From: [Hurley, Bobbie](#)
To: [Freeman, Carol](#); [Horton, Ruth M](#)
Subject: FW: Request for farmland conversion impact rating of Clinch River Reactor project
Date: Friday, October 16, 2015 8:43:13 AM
Attachments: [ClinchRiverSMRProject_AD1006_10_16_2015.pdf](#)

FARMLAND CONVERSION IMPACT RATING

Figure 4. CRN Site Prime Farmland Soils

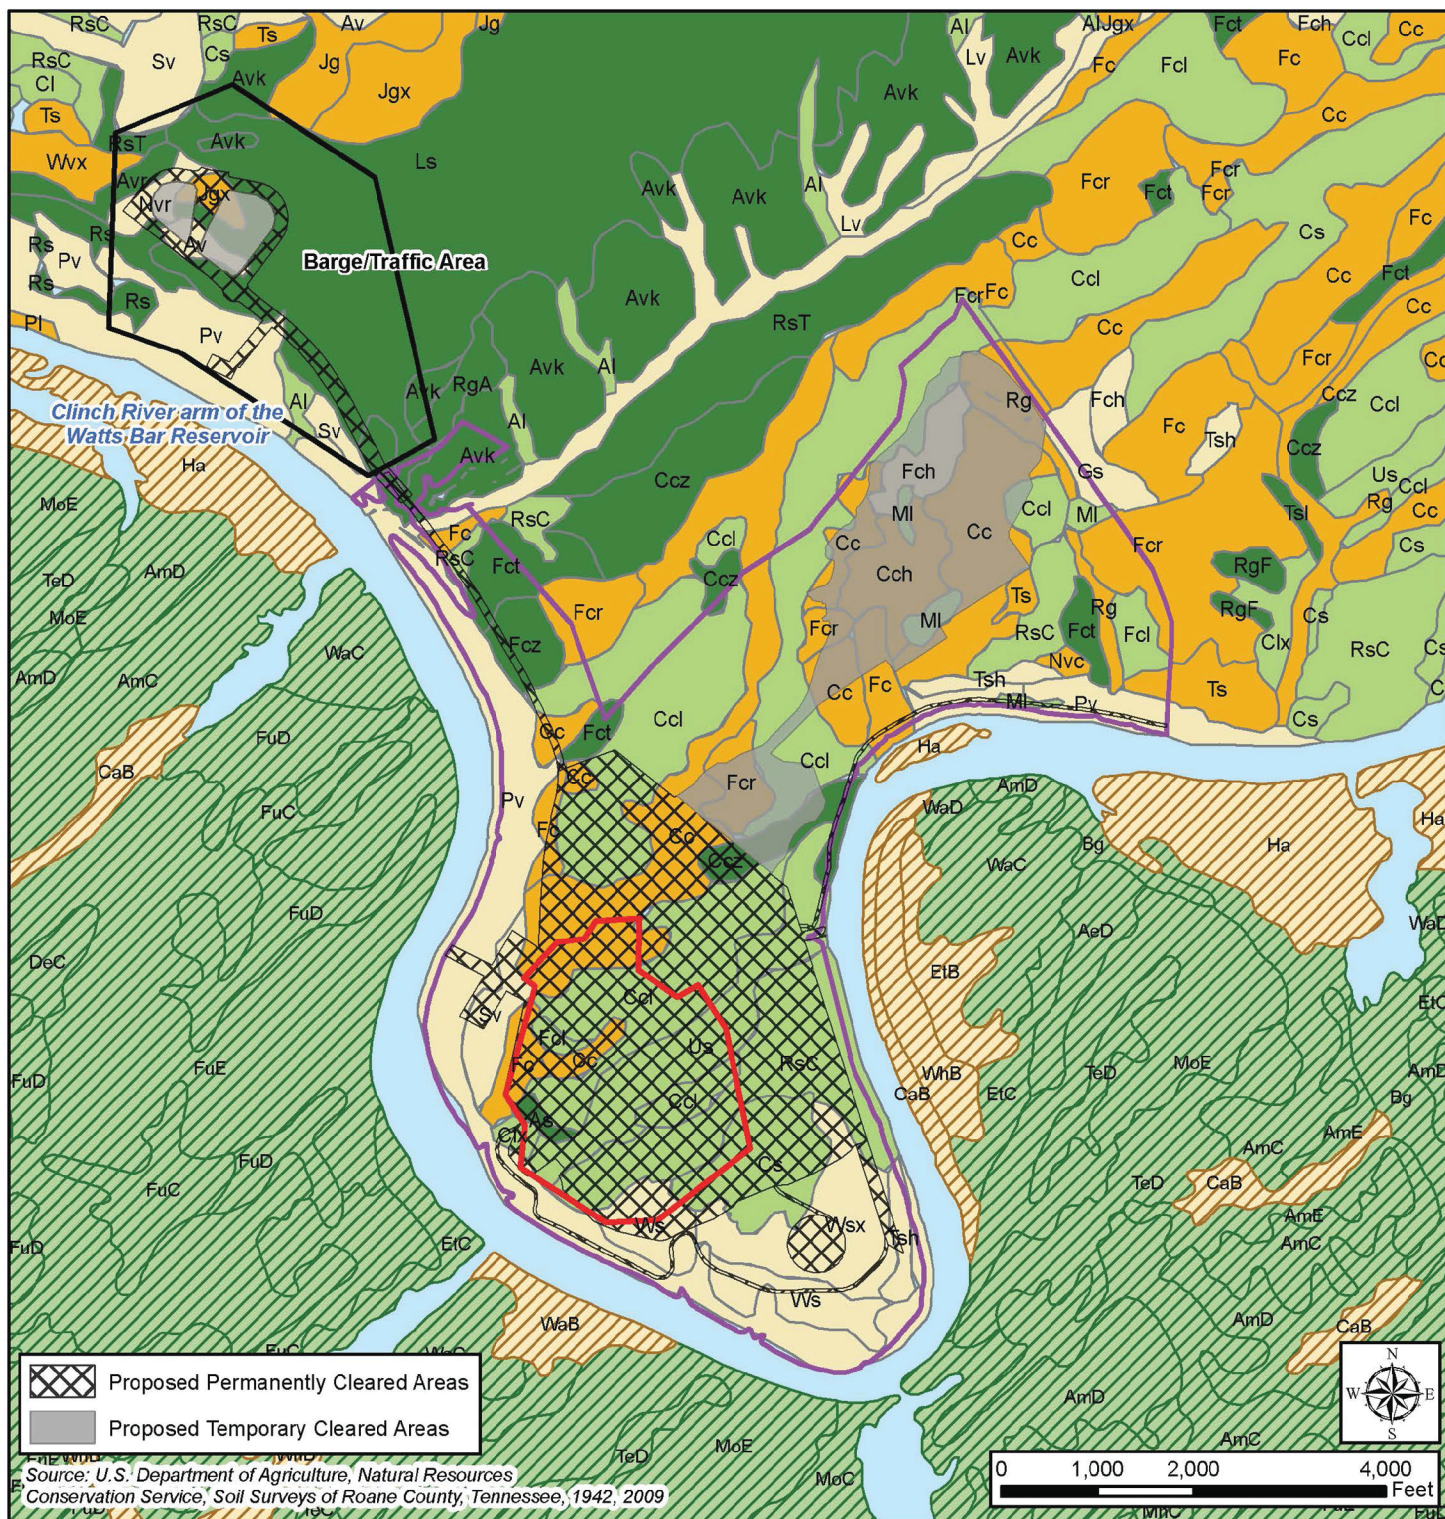
I received your request for Farmland Protection Policy Act (FPPA) review of the Clinch River Reactor project and I need to get a little more information that was not in the documentation that I had forwarded to me. On the enclosed AD-1006, you have listed that the entire 1131 acres will be converted and I wanted to make sure this was correct or is the area that was manipulated in 1983-1984 the area that will be impacted by the overall project (240 acres).

Thank you for your review. Approximately 328 acres would be permanently converted within the

CRN Site, including the entire 240-acre area previously disturbed during the CRBRP. An additional approximately 140 acres within the CRN Site would be temporarily converted as a result of construction activities, mostly to the northeast of the main plant site. Within the offsite Barge/Traffic area approximately 30 acres would be permanently converted (of which approximately 12.1 acres have been previously disturbed) and an additional 15 acres would be temporarily converted. Overall, the entire 935 acres of the CRN site would be unavailable for use as farmland because the site would be restricted access. Much of the Barge/Traffic Area is DOE property that already has restricted access. Attached is a new Figure 4 that shows the permanently and temporarily cleared areas. The GIS files for these are also included for download in the link below. If you need additional information please let me know and we will be happy to assist.
